**Ashard Moore / NextEra Energy**  
**South Platte Solar LLC**  
**Special Use**

**PLANNING COMMISSION HEARING**

**March 13, 2023**

On behalf of South Platte Solar, LLC ("Applicant"), Westwood Professional Services ("Westwood") is providing responses to the Morgan County ("County") review comments pertaining to the South Platte Solar ("Project") Special Use Permit Application ("Application") provided on January 19, 2023, during a phone call with Nicole Hay of the Morgan County Planning and Zoning Department. The review comments and corresponding responses are grouped by Application section, with comments denoted in bold italics and responses immediately subsequent.

1 OVERALL SITE LAYOUT

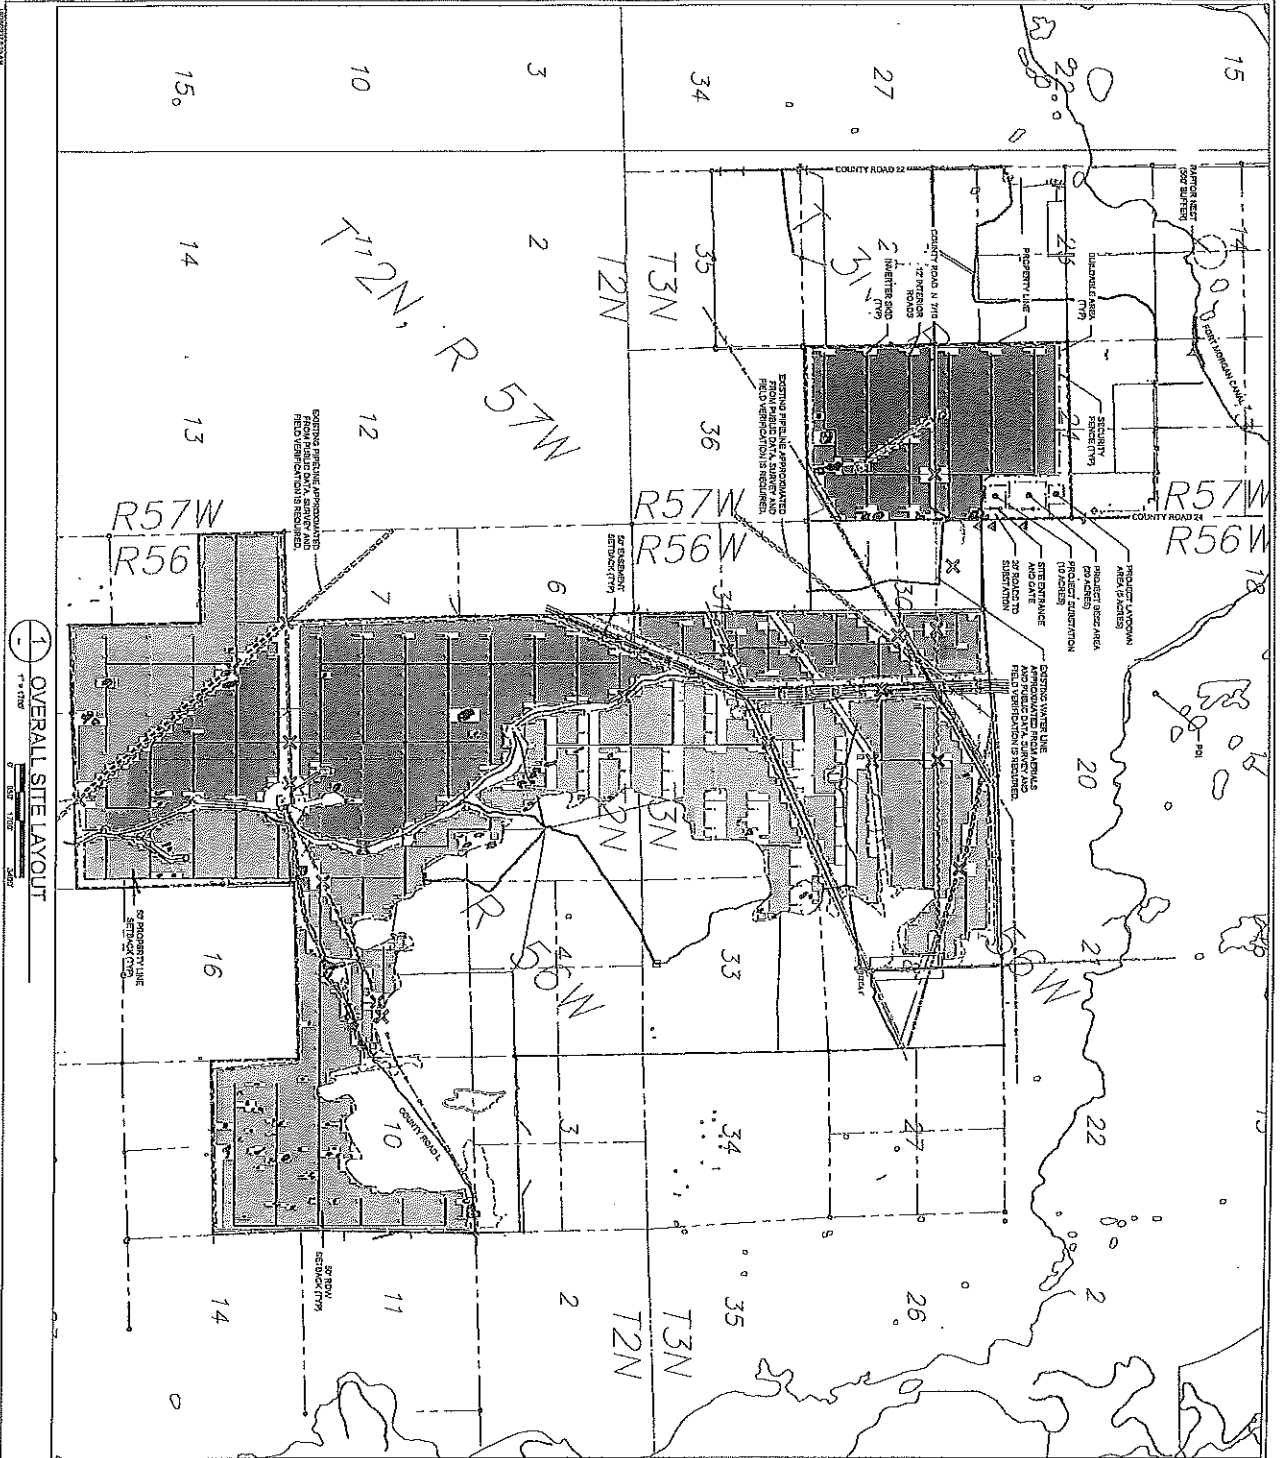
### **Issued for Permitting Civil Design Plan Set**

The Issued for Permitting Civil Design Plan Set has been revised to incorporate all requisite setback requirements and is included in **Attachment 4**.
